Access Compliance Report

Public Rights-of-Way

(Curb Ramps)

Intersection ID: 24455	Main Street: S_TRYON_ST	Cross Street: STEELE_CREEK_RD	Location: NE
ADA ID: 1ADB843D82E2	Ramp Type: Perp	Initial Pass/Fail: Fail	Overall Compliance: No
Severity Score: 10			
Codes/Mitigation Info/Possible Solution		Field Measurements/Component Compliance

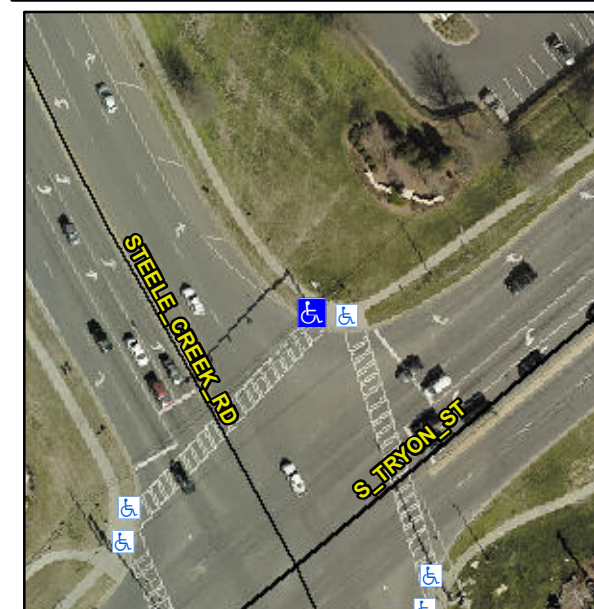
Not Found, R304.5.1, R304.5.3

Compliance	Description	Data	Compliance	Description	Data
N/A	Ramp Length (in)	84.0	Yes	Ramp Slope (%)	6.6
No	Ramp Width (in)	47.0	No	Ramp XSlope (%)	2.6
N/A	Flare Type LT	N/A	N/A	Flare Type RT	N/A
N/A	Flare Slope LT (%)	N/A	N/A	Flare Slope RT (%)	N/A
N/A	Flare Traversable LT?	N/A	N/A	Flare Traversable RT?	N/A
N/A	Landing Length (in)	N/A	N/A	DWS Provided?	N/A
N/A	Landing Width (in)	N/A	N/A	DWS Contrast?	N/A
N/A	Landing Slope (%)	N/A	N/A	DWS Length (in)	N/A
N/A	Landing X Slope (%)	N/A	N/A	DWS Full Width?	N/A
N/A	Landing Curb? (Y/N)	N/A	N/A	DWS Offset (in)	N/A
N/A	Shared Landing?	N/A			
N/A	Gutter Ponding?	N/A	N/A	Gutter Slope (%)	N/A
N/A	Gutter Lip Ht (in)	N/A	N/A	Gutter X Slope (%)	N/A
N/A	Painted X Walk1?	Yes	N/A	Painted X Walk2?	N/A
	X Walk 1 Direction	To SW		X Walk 2 Direction	N/A
N/A	X Walk 1 Width (in)	120.0	N/A	X Walk 2 Width (in)	N/A
	X Walk 1 Slope (%)	1.7		X Walk 2 Slope (%)	N/A
	X Walk 1 X Slope (%)	2.2		X Walk 2 X Slope (%)	N/A

Remove & Replace Entire Ramp.
